APPLICATION FOR
AMENDMENT OF CONDUIT EXEMPTION

JIM KNIGHT
HYDROELECTRIC PROJECT

FERC NO. P-7686

Applicant: Big Wood Canal Company

EXHIBIT F-1

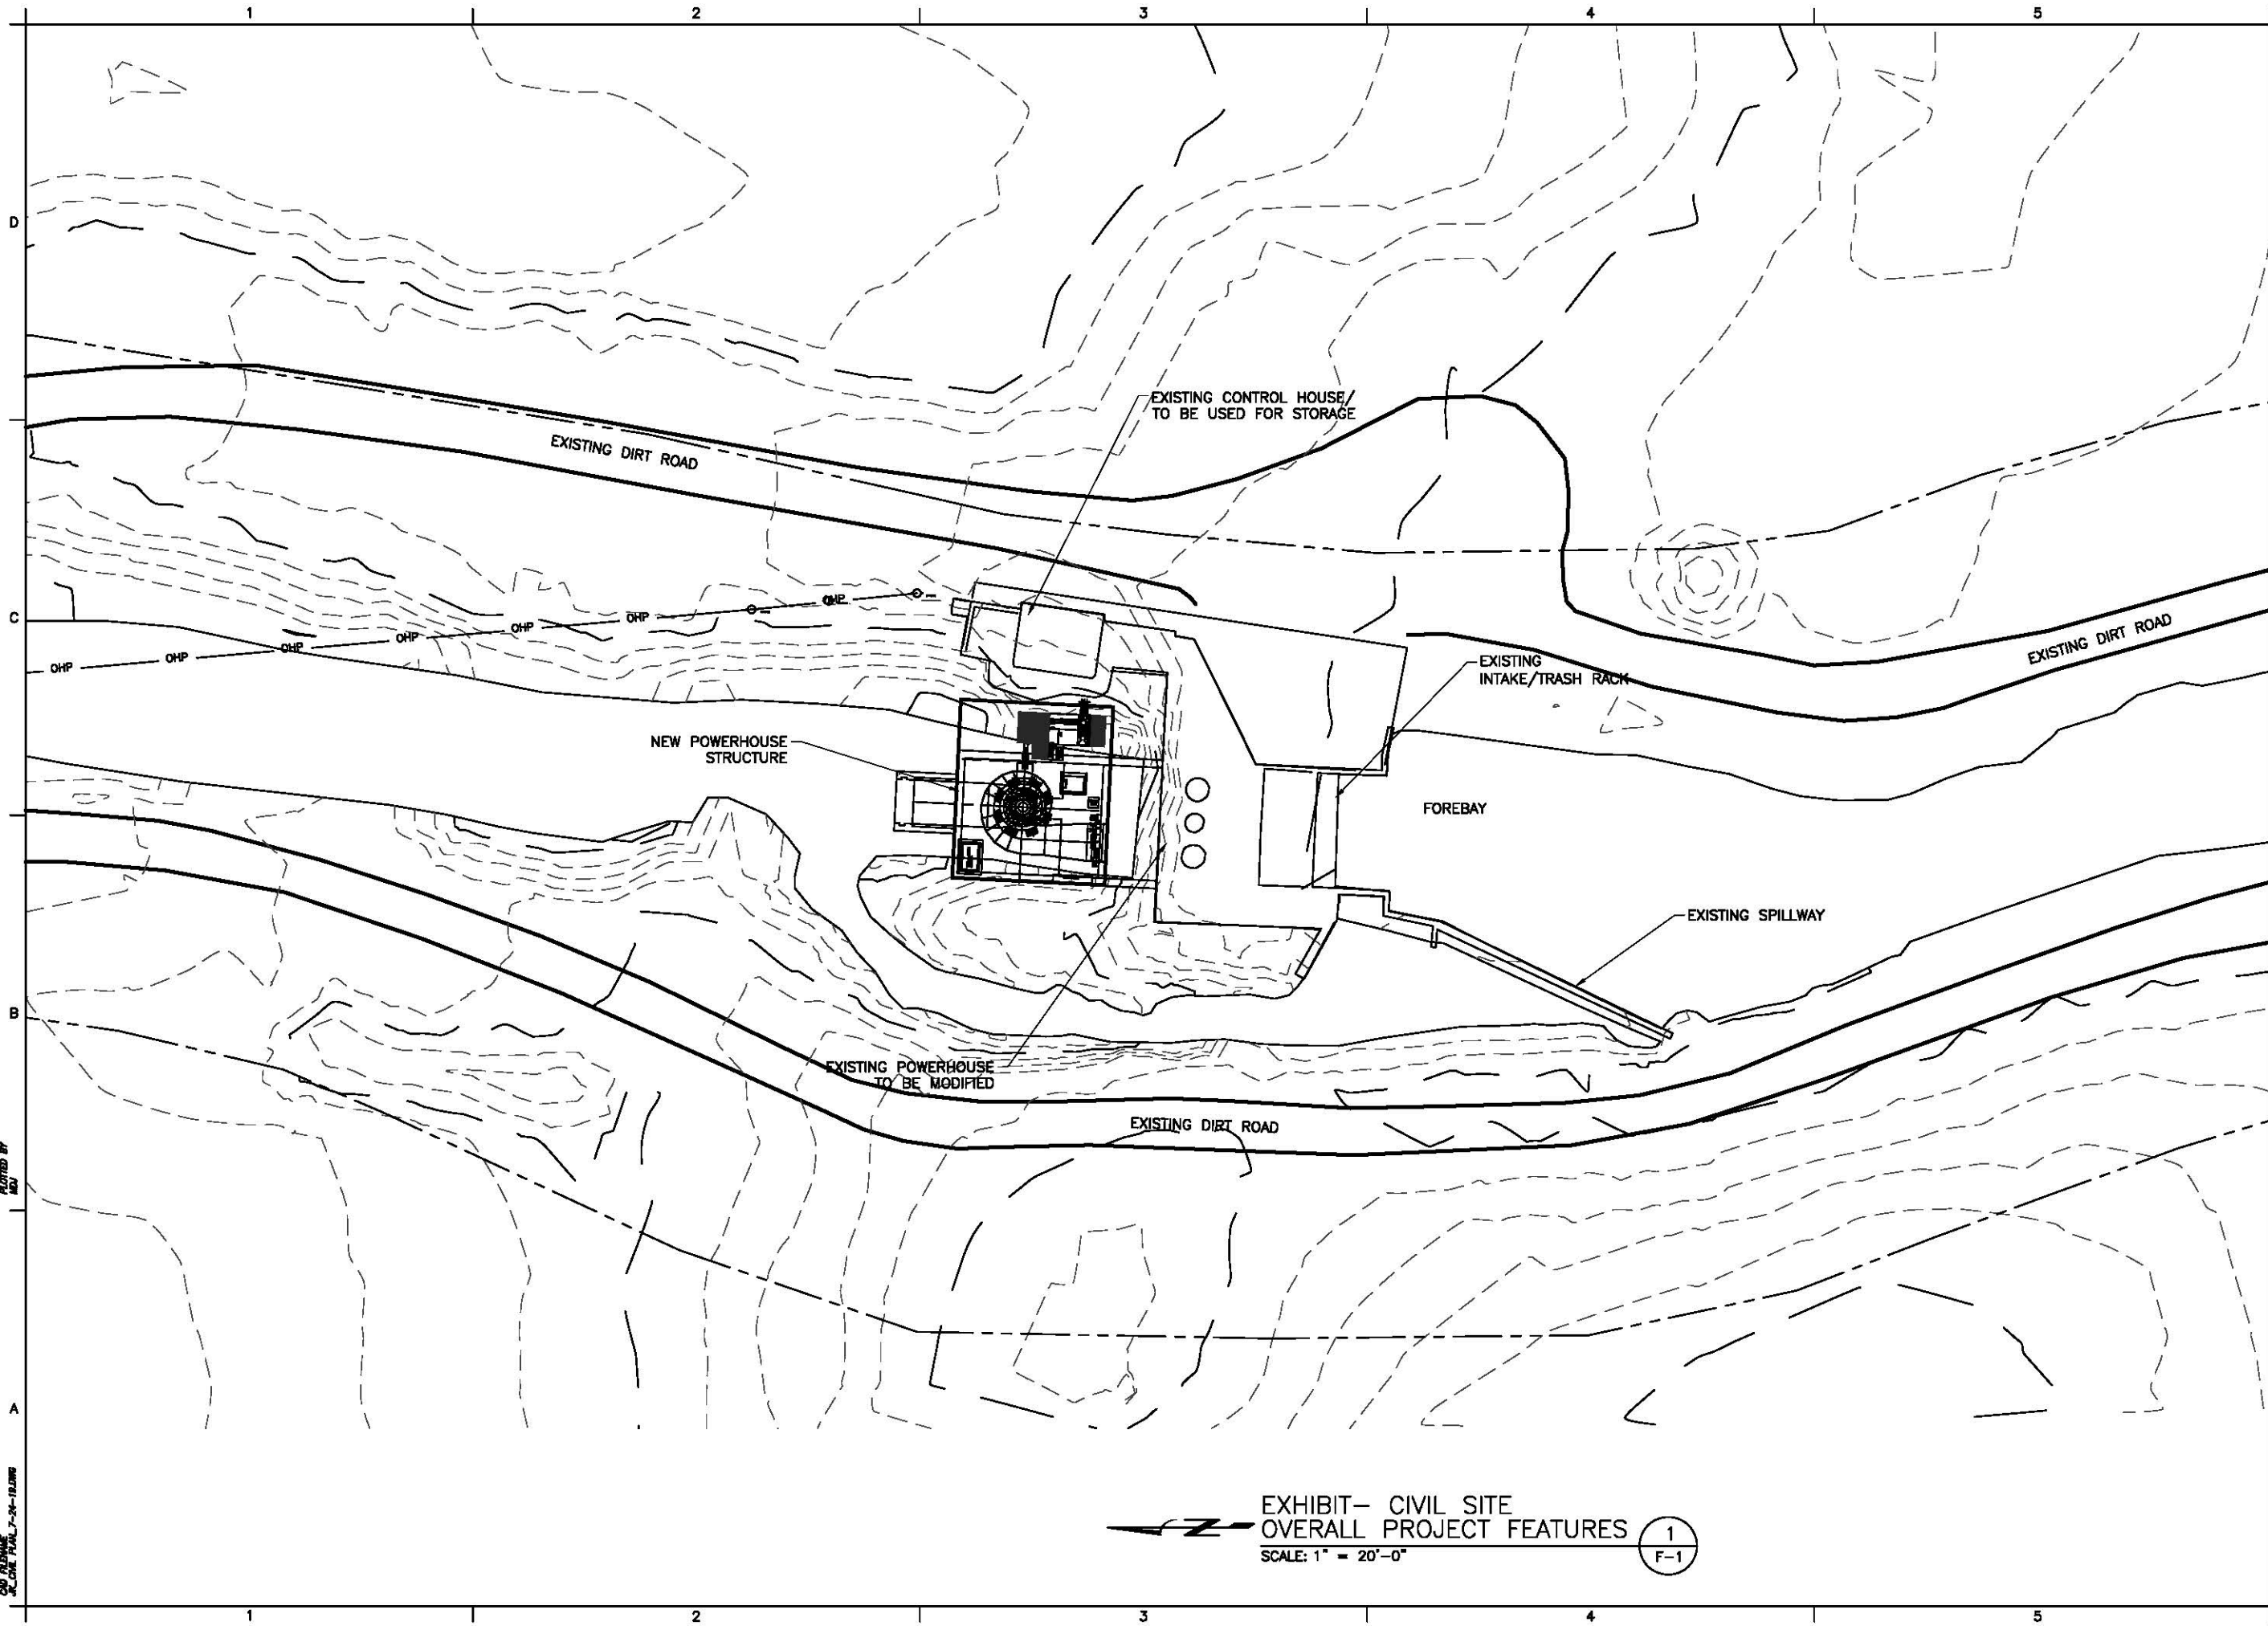
1. Remove three reversible pump turbines, generators and other equipment from existing powerhouse;
2. Remove existing powerhouse and intake structure;
3. Construct new intake structure and 30 ft x 35 ft powerhouse at the downstream end of the original powerhouse foundation;
4. Install single vertical Kaplan turbine with 475 KW installed capacity.

The new design, which is the subject of this amendment application, would consist of a new intake structure and powerhouse at immediately downstream of the original facility. The powerhouse would contain a single vertical Kaplan turbine. The installed capacity would be 475 KW. No change in the amount or timing of water flow in the South Gooding Main Canal is proposed.

EXHIBIT F-2

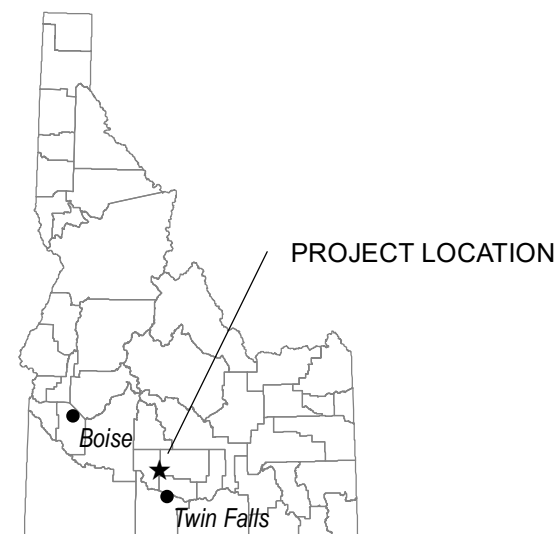
The intake structure would be moved downstream approximately 150 ft from the original location and tied to the old powerhouse foundation. This change allows the intake structure to be integrated with the new powerhouse. The intake structure would incorporate a trash rack and means for dewatering the powerhouse but would not include a flow control gate. The existing spillway would be retained and would maintain the forebay pool at a constant elevation, just as with the original powerplant configuration. See Exhibit F-2.
